Quality Control Check Report. Stage: After Brickwork (Apartments/ Lab Spaces)

Flat No.	A - 305	Others	-	Sl. No.	40958
Company	MRGV	Project	BRGV	Phase	-
Prepared by	K. Sneha	Sign	Sneha	Date	12-12-2021
Project Manager	Sarwar	Sign	Sarwar	Date	12-12-2022
Previous Stage report no.	39970	Report filed and signed by PM?	☒ Yes ☐ No		
Apartment No.		Other		other	
Checked By MD on		MD Sign		For filling	☐ Yes ☐ No
Recommendation: ☐ Stop further work. Submit ATR on QC report to QC team. Proceed only after recheck by QC. ☐ Stop further work. Proceed with work after submitting ATR on QC report to QC team. ☒ Proceed with further work only after making corrections pointed out in the QC report. ATR not required. ☐ Proceed with further work. ATR not required.

ATR on Quality Control Check Repot. (Bungalows)

Description
QC check ELECTRICAL PLAN
FLAT.NOS. 101, 103, 105, 107, 109 & 111

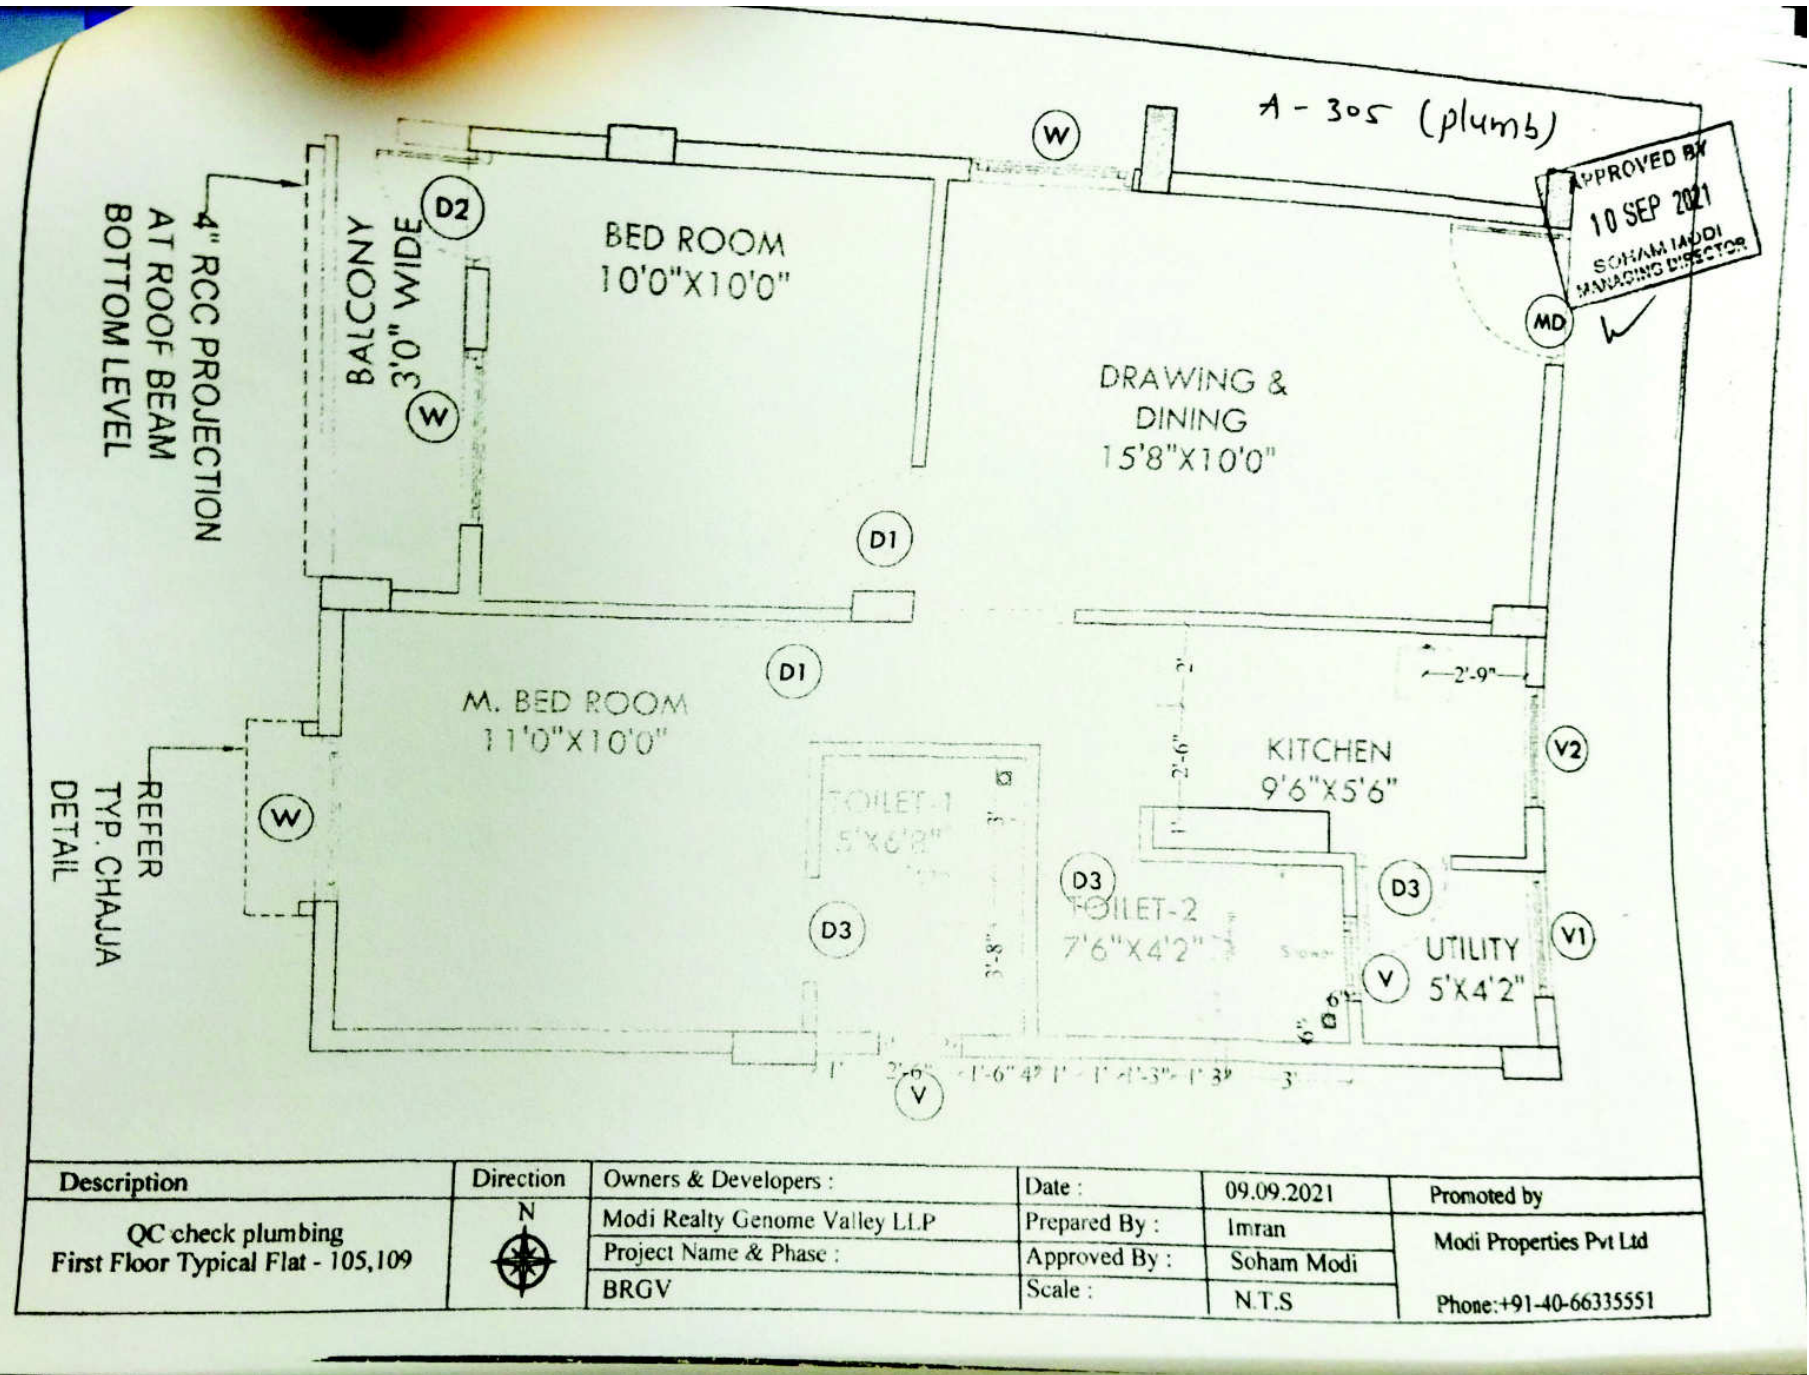
A - 305 (Elect)

Description
QC check ELECTRICAL PLAN
FLAT.NOS. 101, 103, 105, 107, 109 & 111

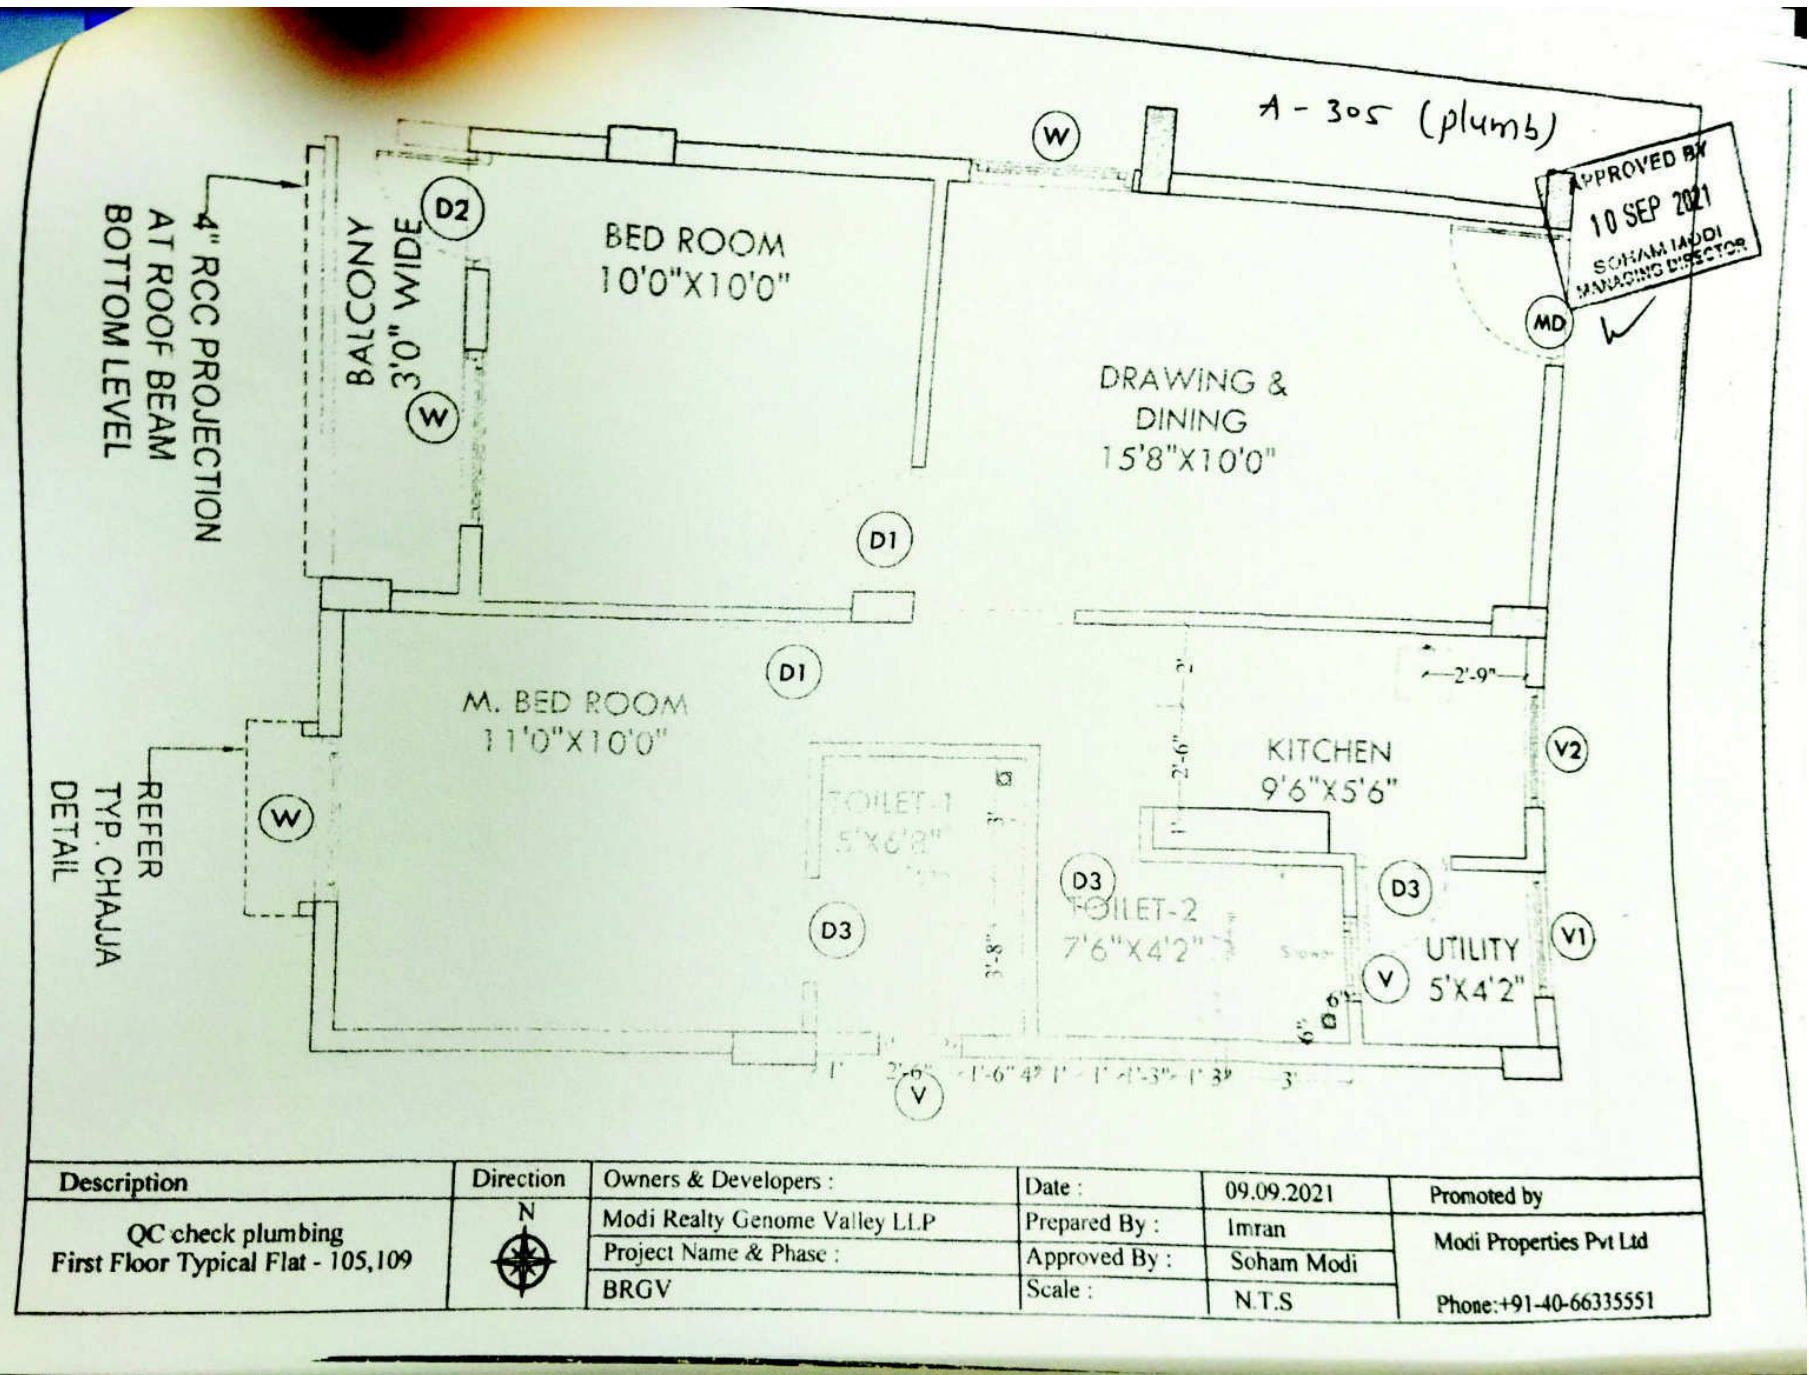
A - 305 (Elect)
